APPLICATION NO.	FILING DATE	FIRST NAMED INVENTOR	ATTORNEY DOCKET NO.	CONFIRMATION NO.
10/614,271	07/07/2003	David C. Swenson	MSH - 243	7747
8131	7590	01/07/2005	EXAMINER	
MCKELLAR IP LAW, PLLC 784 SOUTH POSEYVILLE ROAD MIDLAND, MI 48640			LUONG, VINH	
			ART UNIT	PAPER NUMBER
			3682

Office Action Summary

4. The drawings were received on August 25, 2003. These drawings are not accepted by the Examiner because of the reasons, *e.g.*, listed in the objection below.

ATTACHMENT # 1

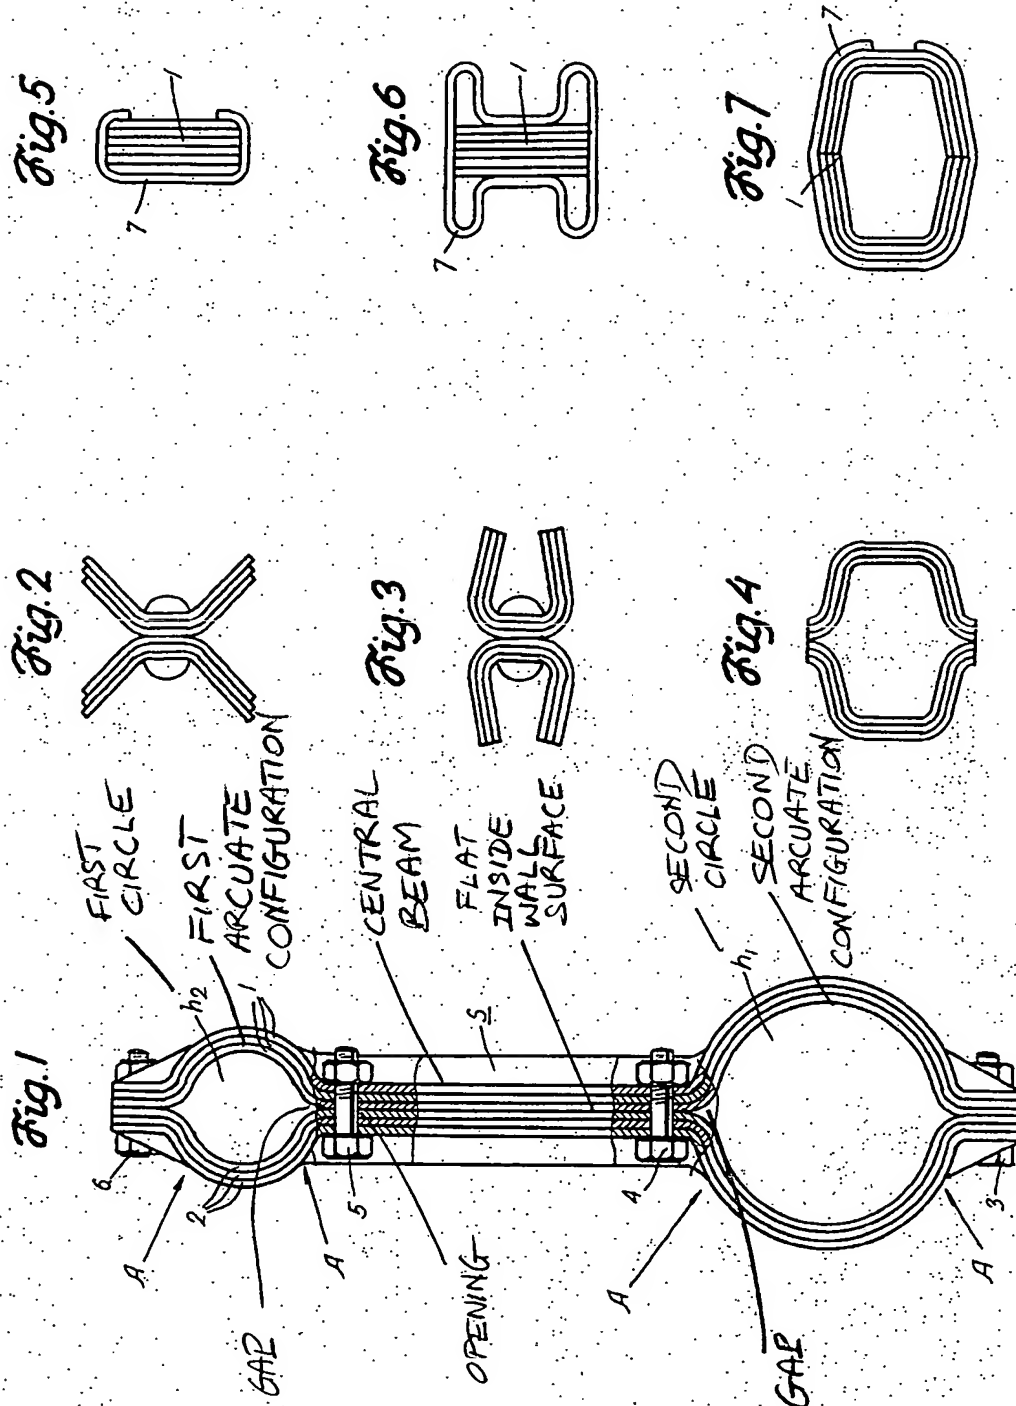
(i) two symmetrical rods 1 and 2 of equivalent size; each said rod 1 or 2 manufactured of modified metal; each said rod 1 or 2 comprising a central beam S having a near end and a distal end and an inside wall surface (unnumbered. See Attachment 1); each distal end terminating in a first arcuate configuration (Att. 1); each near end terminating in a second arcuate configuration (Att. 1) such that upon joining the rods 1 and 2 together the first arcuate configurations form a first circle h_2 and the second arcuate configurations form a second circle h_1 ; each of the arcuate configurations having a near end and a distal end wherein each distal end has an opening (Att. 1) at the terminus thereof to receive a fastening device 3-6;

(ii) each said rod 1 or 2 having an opening located in the central beam between the first arcuate configuration (Att. 1) and the second arcuate configuration (Att. 1), wherein all openings are directed through the inside wall surface thereof. Id., claims 1-9.

Regarding claim 5, the rods 1 and 2 are assembled such that there is a gap (Att. 1) provided between the inside surface of the beams.

Regarding claim 6, the inside surface of each beam between the first and second arcuate configurations is flat (Att. 1).

Regarding claims 9, the opening (Att. 1) located between the first arcuate configuration and the second arcuate configuration is not at the midpoint.

ATTACHMENT # 2

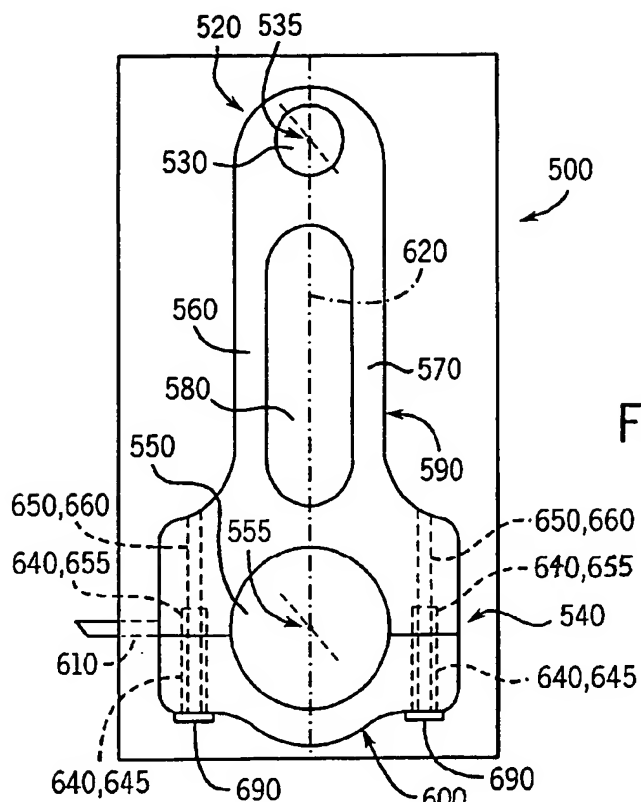
(i) two symmetrical rods 560 and 570 of equivalent size; each said rod 560 or 570 manufactured of modified metal; each said rod 560 or 570 comprising a central beam having a near end and a distal end and an inside wall surface (unnumbered. See Attachment 2); each distal end terminating in a first arcuate configuration (Att. 2); each near end terminating in a second arcuate configuration (Att. 2) such that upon joining the rods 560 and 570 together the first arcuate configurations form a first circle 530 and the second arcuate configurations form a second circle 550; each of the arcuate configurations having a near end and a distal end wherein each distal end has an opening 670, 680 at the terminus thereof to receive a fastening device;

(ii) each said rod 560 or 570 having an opening 580 located in the central beam between the first arcuate configuration (Att. 1) and the second arcuate configuration (Att. 1), wherein all openings 670, 680, 580 are directed through the inside wall surface thereof. Id., claims 1-20.

Regarding claim 5, the rods 560 and 570 are assembled such that there is a gap 580 provided between the inside surface of the beams.

Regarding claim 6, the inside surface of each beam between the first and second arcuate configurations is flat (Att. 2).

Regarding claim 7, the inside surface of each beam 560, 570 contains a channel 580 therein running *essentially* the length of the flat inside surface.
